RE: File Number: SP-2022-07
TFP Aurora (Block 38) Limited, 25 Mavrinac Boulevard
Site Plan Application for Seniors' Residence: Block 38 on Plan 65M-4731

On behalf of TFP Aurora (Block 38) Limited, we are submitting revised materials for the Site Plan application for proposed senior's residence located at 25 Mavrinac Boulevard (Block 38 on Plan 65M-4731).

#	Comment	Consultant	Response
The following comments are conditions that must be met:			
38.	Please note that the minimum number of accessible parking spaces is 5 parking spaces underground for the use of persons with disabilities, which meets the requirements of the AODA Design of Public Spaces O.Reg 191/11, section 80.36 (3).	Global	The development proposed a total of 6 accessible parking spaces, 3 underground and 3 below ground, meeting the AODA Design of Public Spaces Requirements.

1 SITE PLAN
1:200

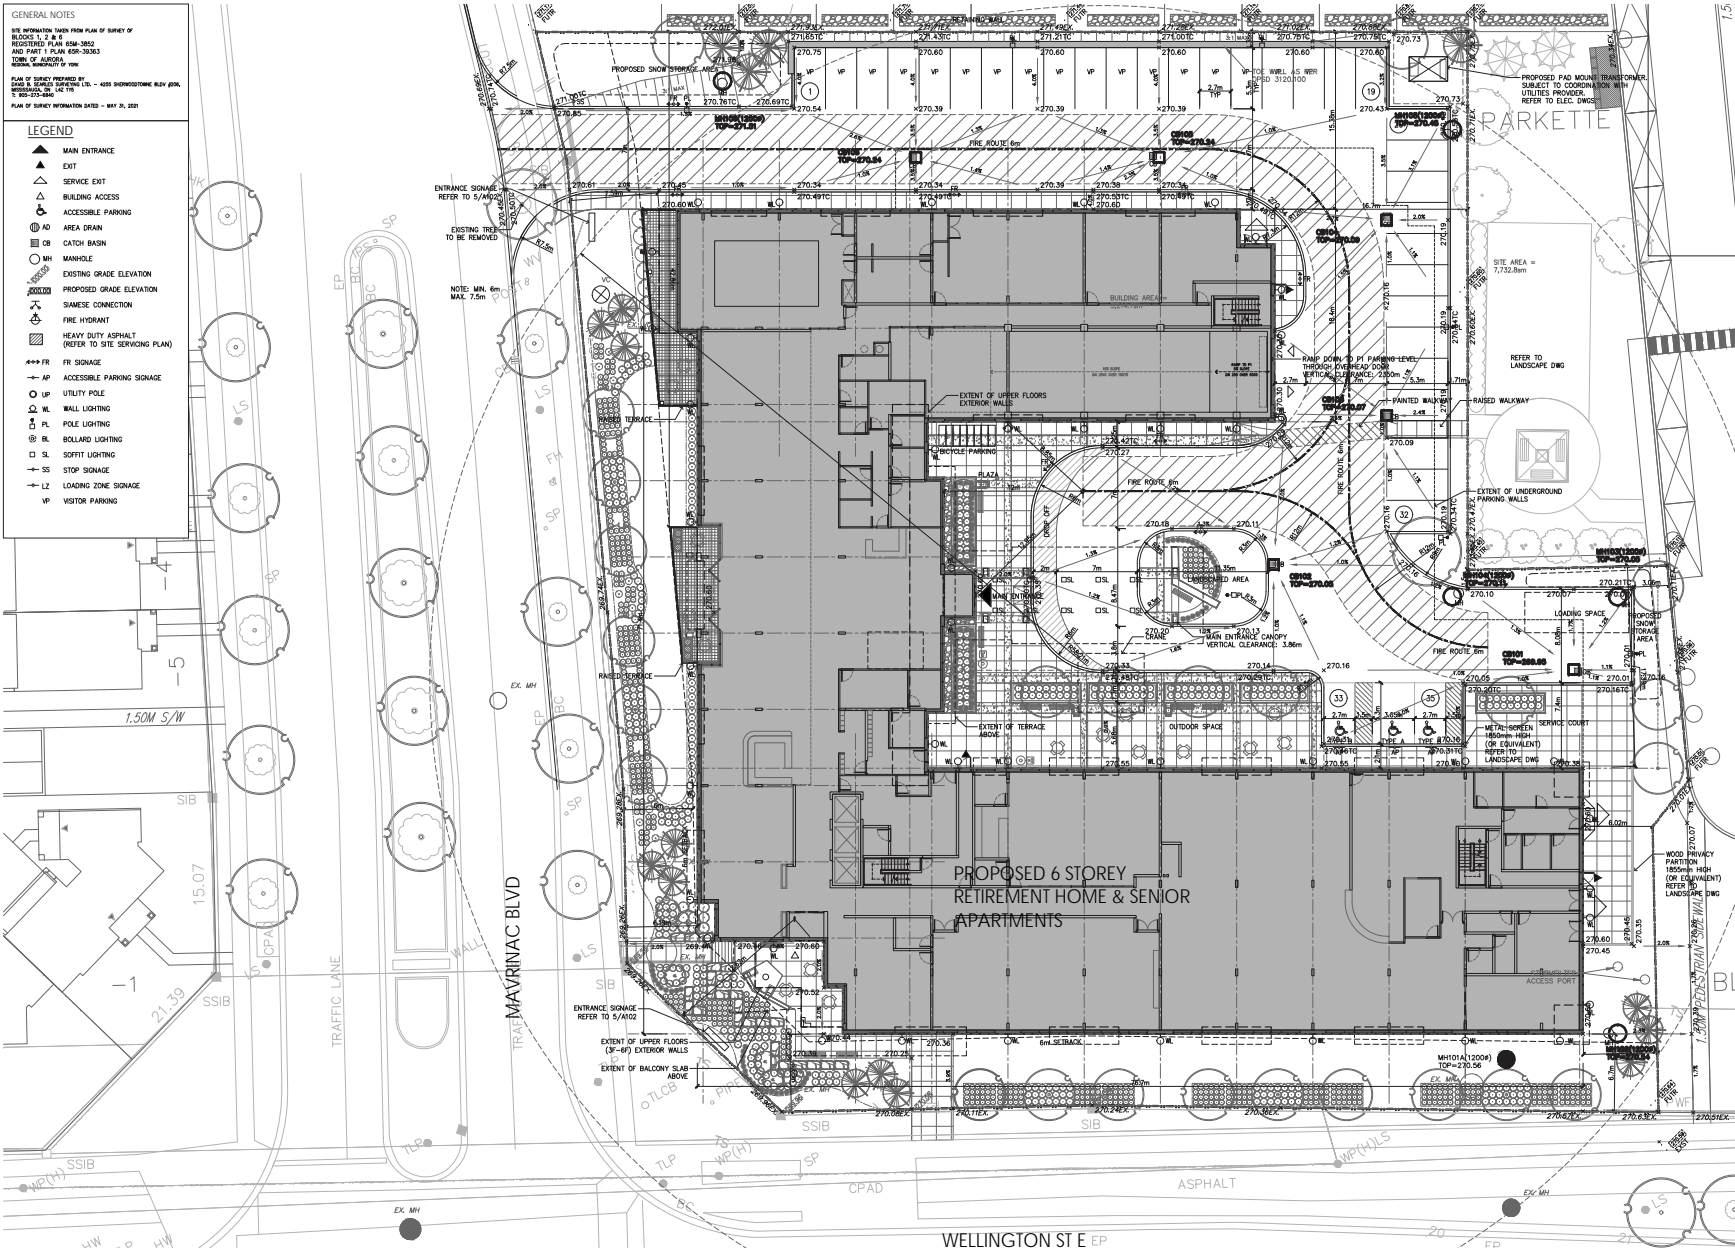
- Three barrier free parking spaces were moved out of the central driveway;
- A staircase to Mavrinac Boulevard has been provided at southwest corner of the building;
- Two outdoor amenity spaces (terraces) were added on the west side of the building on the ground floor;
- Additional snow storage is provided on the east side of the site; and
- Colour palette/materials

49.	A total of 17 visitor parking spaces are required. The site plan does not show the location of the visitor parking spaces.	Global	17 Visitor Parking Spaces have been identified on the site plan.
